**ONSITE SEWAGE DISPOSAL SYSTEM**

PROPERTY ADDRESS: 13864 Mill Creek Court

SUBDIVISION: Crawford Subdivision

**ONSITE SEWAGE DISPOSAL SYSTEM DESIGN PLAN**

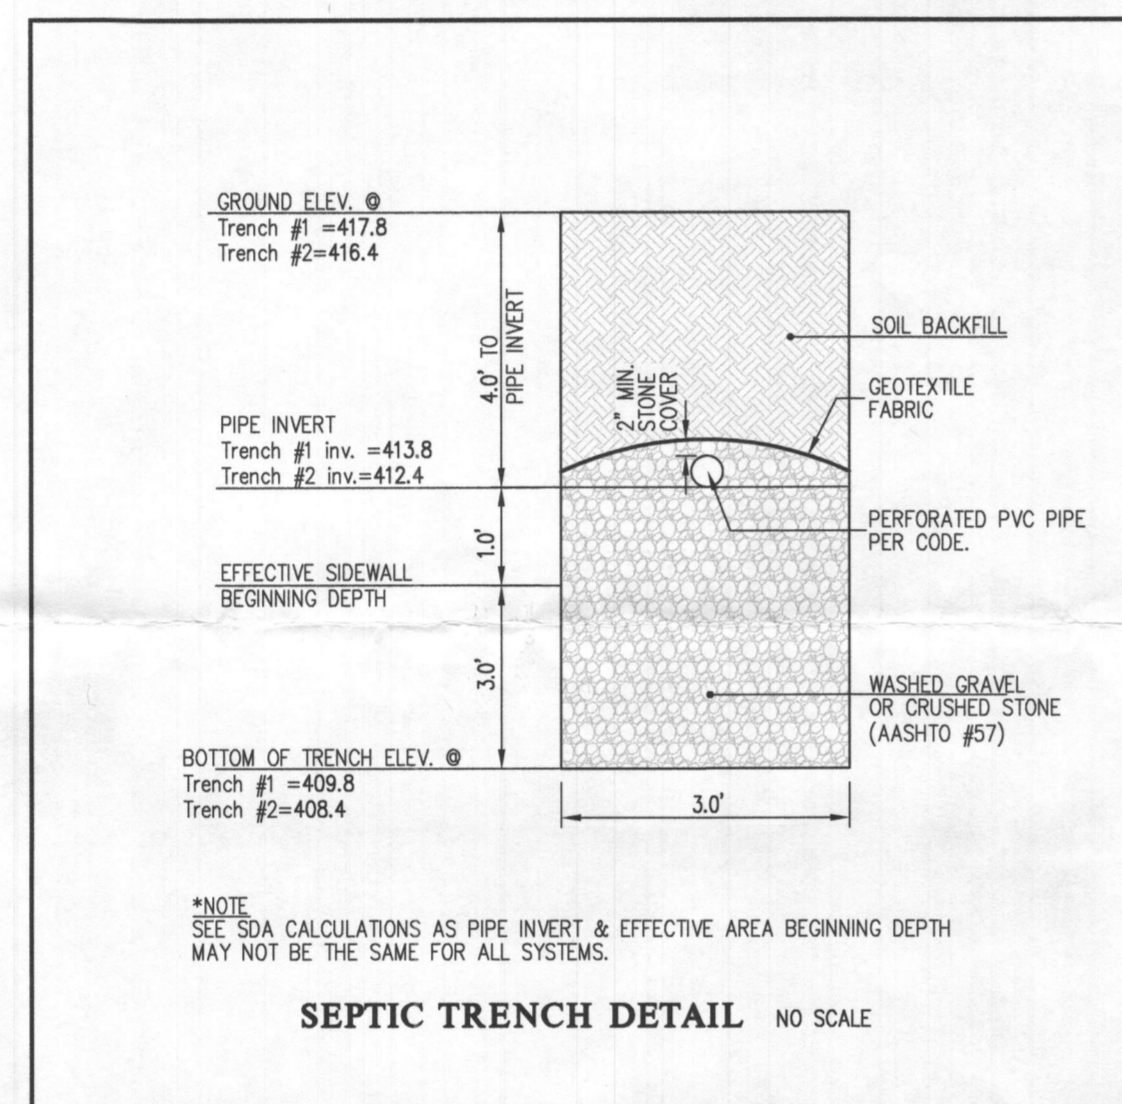
Lot 11 at 13864 Mill Creek OSDS plan has been approved. However, the location of the distribution box may not provide the most efficiency and may be adjusted in the field during the layout inspection.
